Class 1 Permit Modification Notifications

**Waste Isolation Pilot Plant
Carlsbad, New Mexico**

WIPP HWFP #NM4890139088-TSDF

July, 2008

Figure F-3
 WIPP Underground Facilities

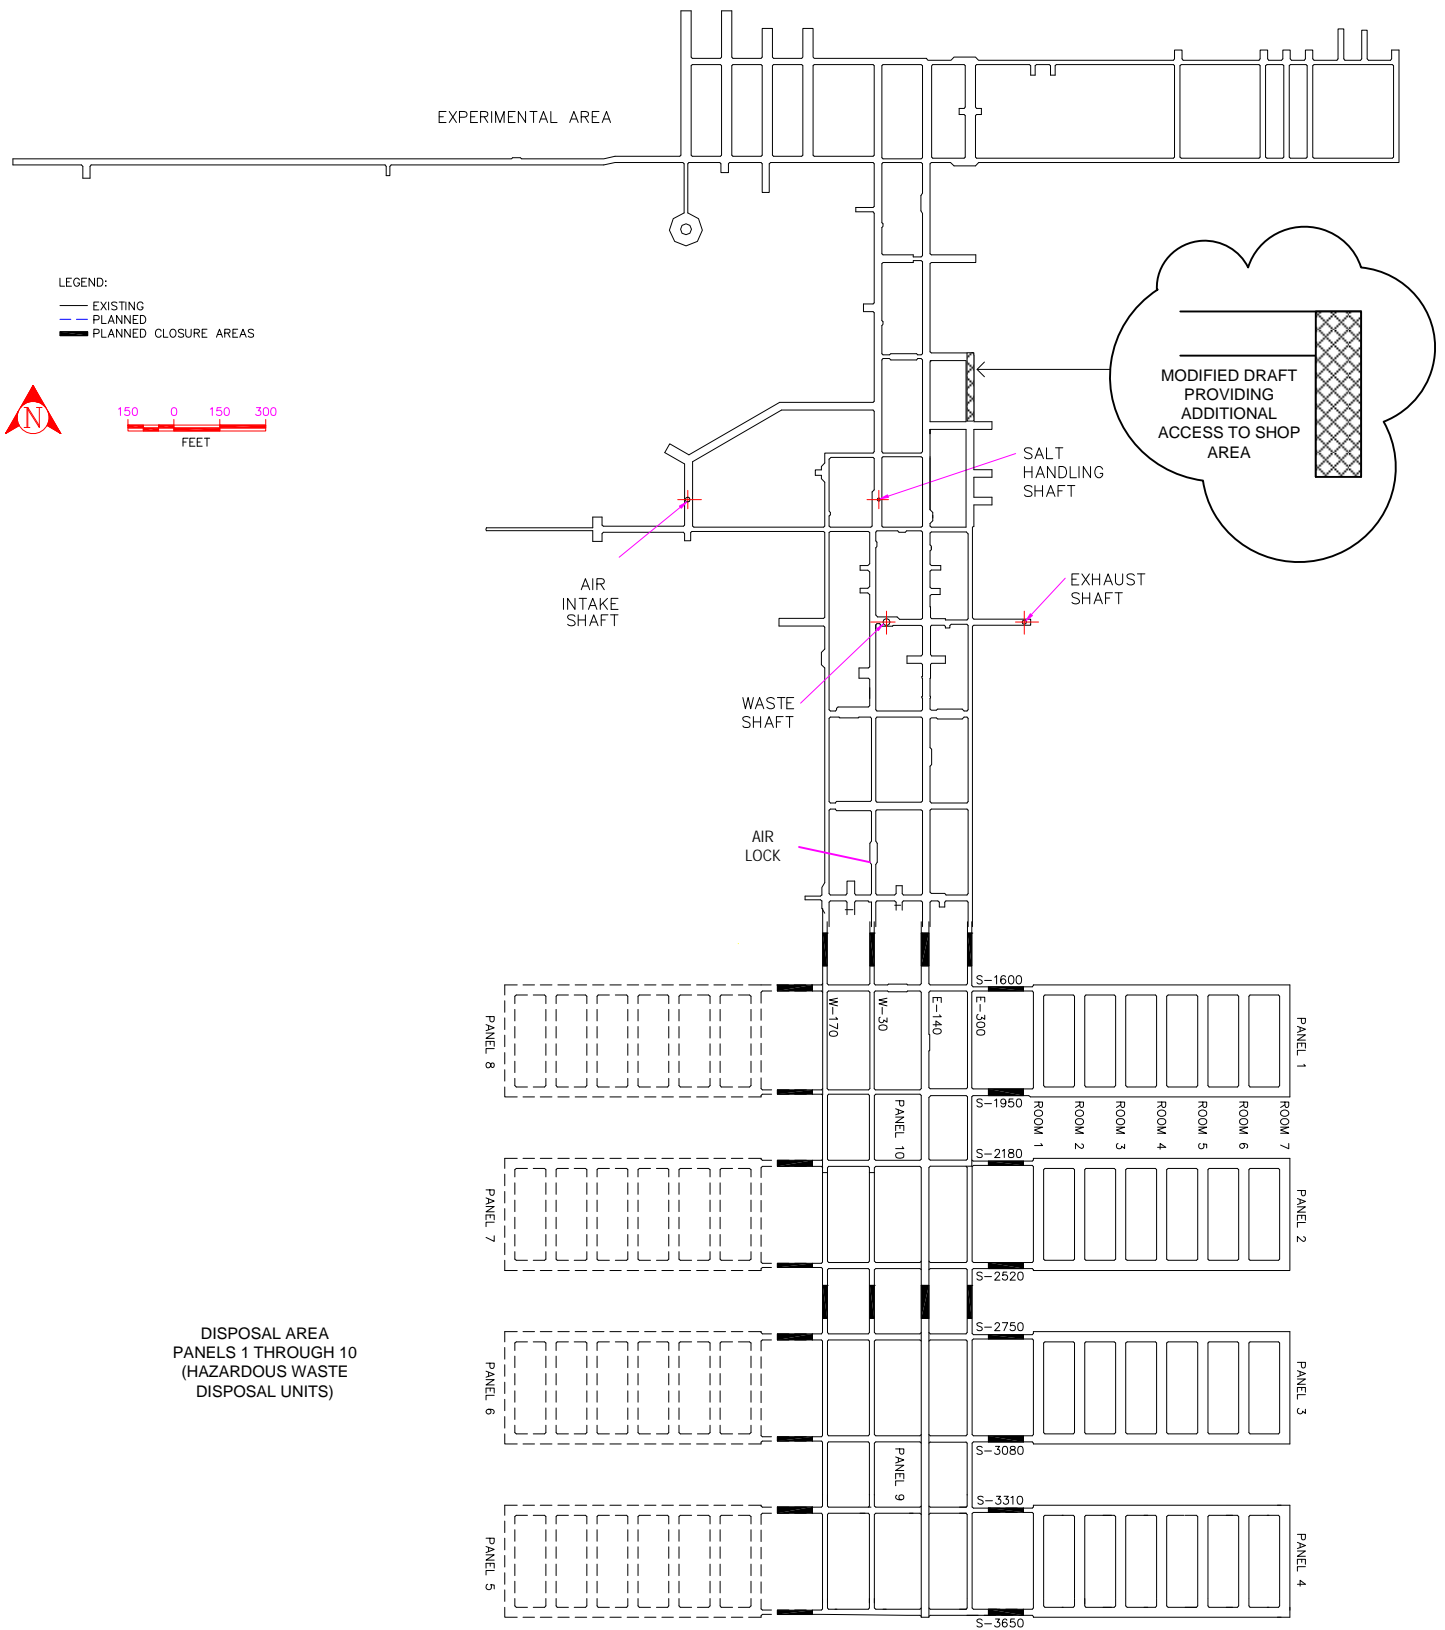
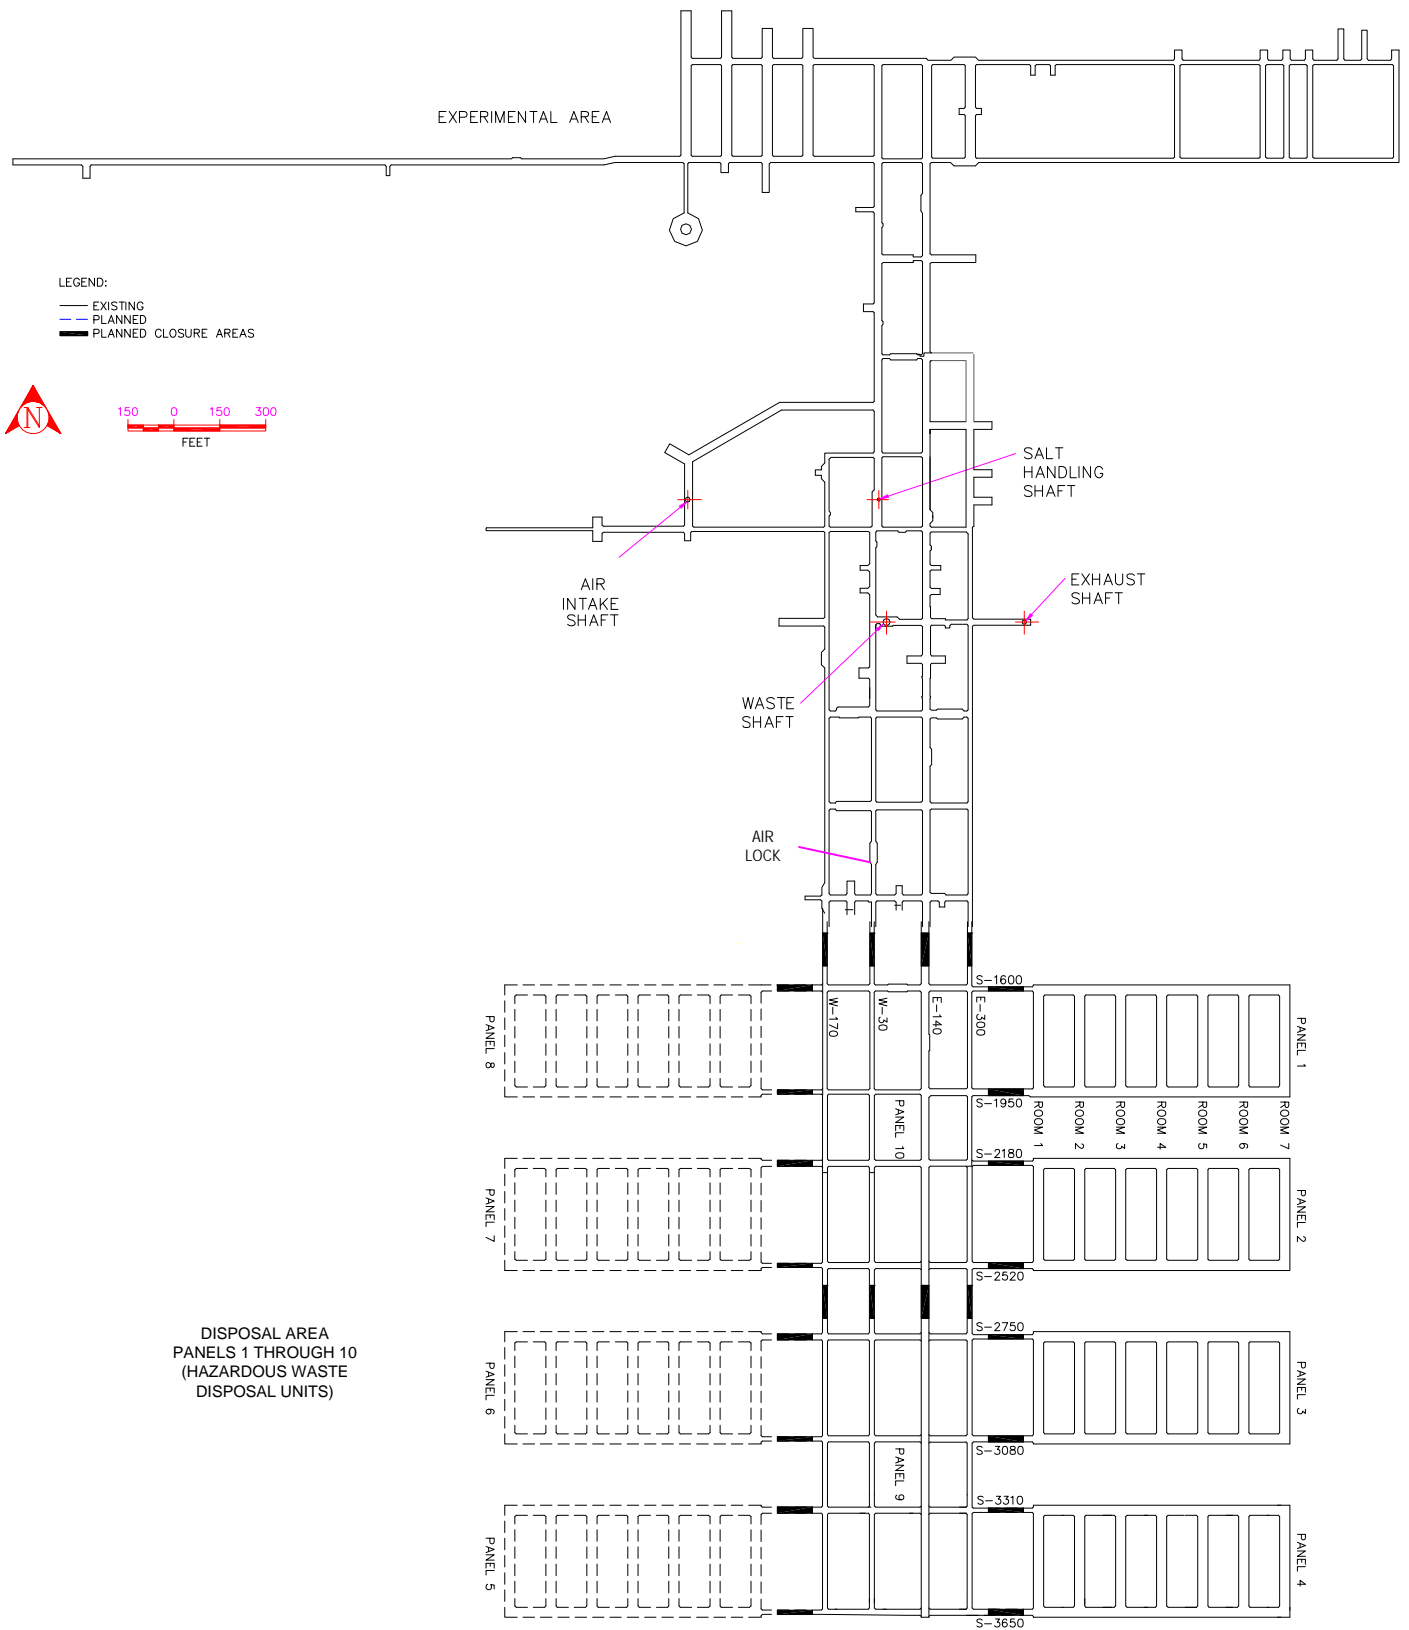
Discussion: Various figures in the HWFP of the WIPP underground area are being revised to reflect a new area mined for underground shops. These include Figures F-3, F-5, I-6, M2-1, M2-2, N-1, O3-1 and O3-2. Figure F-3 has been annotated with a "cloud" showing where the change was made. This figure is for informational purposes only. Included in Attachment B of this notification are "clean" figures with the change incorporated.

Revised Figures F-3, F-5, I-6, M1-1a, M2-1, M2-2, N-1, O3-1 and O3-2 are included in Attachment B.

Figure M1-1a
Waste Handling Building Plan (Ground Floor)

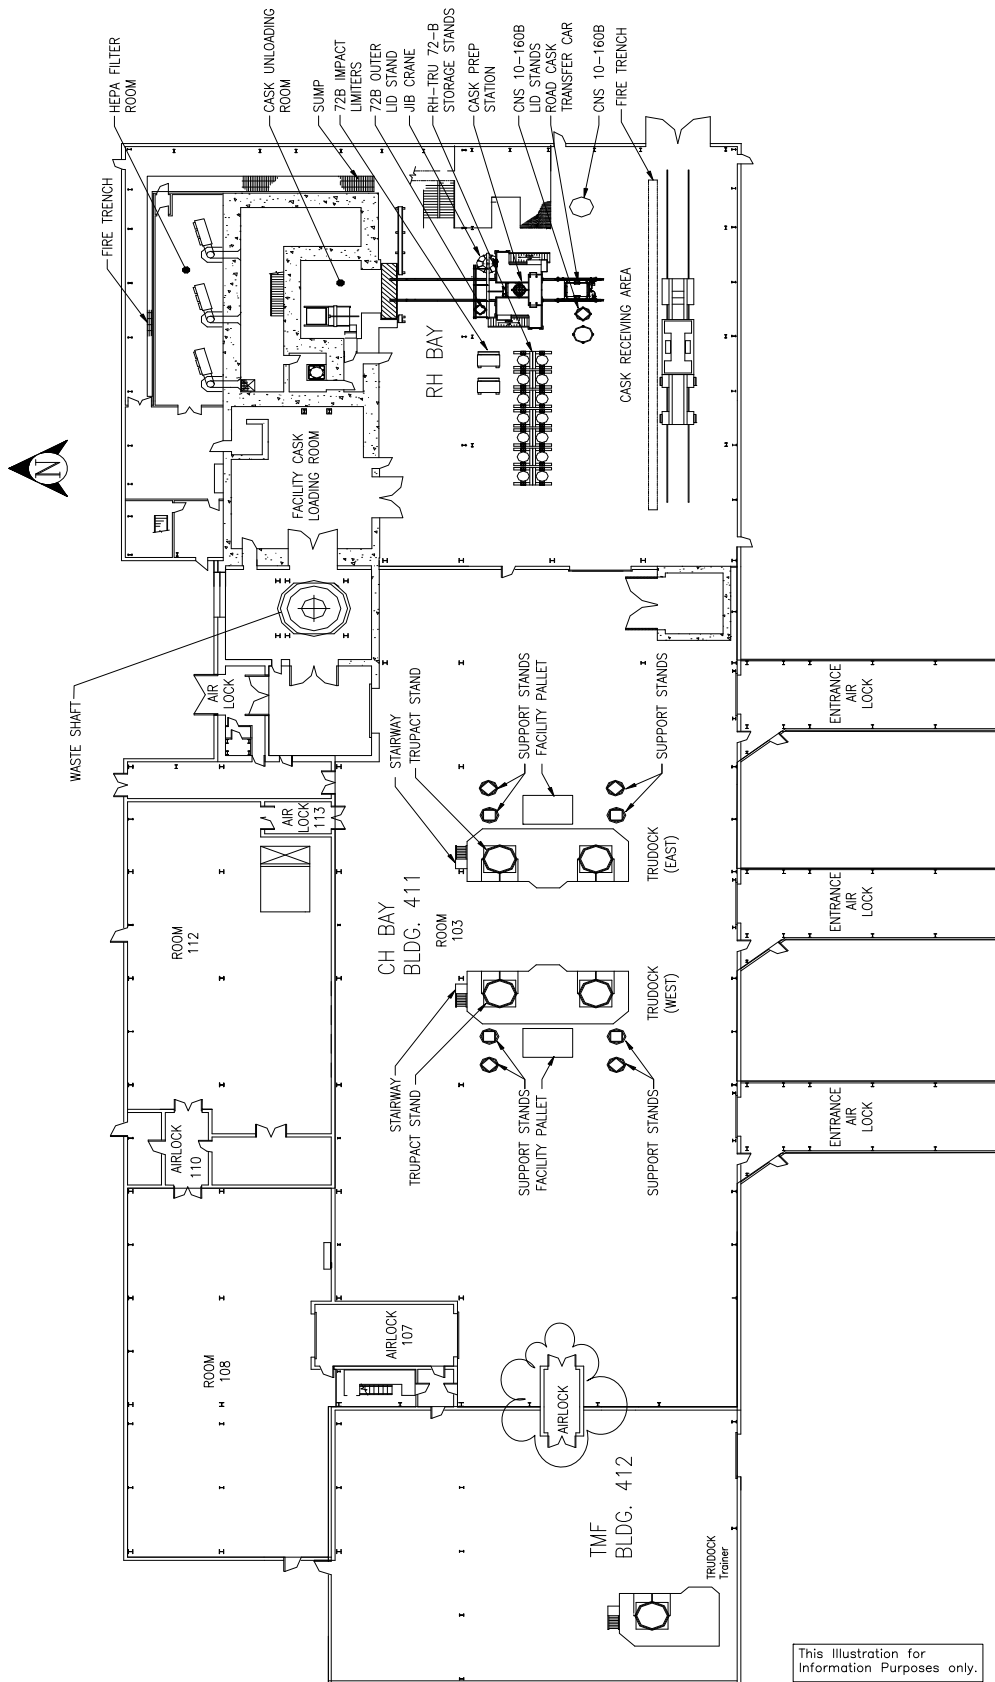
Figure M1-1a is being revised to indicate that an airlock does not exist between the Waste Handling Building and the TMF. Figure M1-1a has been annotated with a "cloud" showing where the change was made. This figure is for informational purposes only. Included in Attachment B of this notification is the "clean" figure with the change incorporated.
